Our Ref: 82018194:IP / HC
Contact: Ivo Pais / Hayden Calvey

17 March 2020

**CALDERWOOD MOD 4 APPLICATION
RESPONSE TO RMS DECEMBER 2019 COMMENTS**

Figure 1-1 Diamond Right Turn with Split Phasing

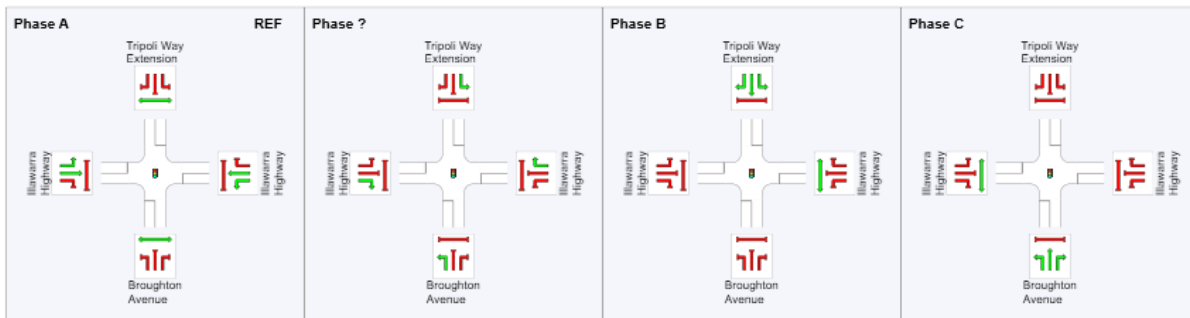
- Remove filter right turns on Illawarra Highway in replacement of leading right turns. TfNSW advised that filter right turns are not a preferred arrangement.
- Revert back to split phasing on Broughton Avenue and Tripoli Way Extension (as per Cardno's original model assumption)
- Ensure pedestrian phases are provided on all approaches
- Review the queue results and ensure the concept designs comply with Austroads.

Cardno has undertaken the additional SIDRA phasing request, with the removal of the filter right turn on both Illawarra Highway approaches, split phasing arrangement for the two side roads and a leading right turn for the eastbound Illawarra Highway approach. Furthermore, an additional test to implement diamond right turn on Illawarra Highway and split phasing on the Broughton Avenue and Tripoli Way Extension roads. The reference to a leading right turn arrangement within the TfNSW letter cannot be achieved for both approaches, rather this would be referred to as a split arrangement. Hence the two phasing arrangements (leading right turn for eastbound with split phasing, and diamond right turn with split phasing) have been tested to provide TfNSW flexibility.

The results of the above phasing arrangements are summarised in **Table 1-1** below. All models presented below consider pedestrian phases on all approaches.

The results show that removal of the filter right turn arrangement results in reduced performance, whereby results have moved from LoS C to LoS D. Previous phasing arrangements that either include the filter right turn on Illawarra Highway, or Double Diamond arrangement, result in LoS C.
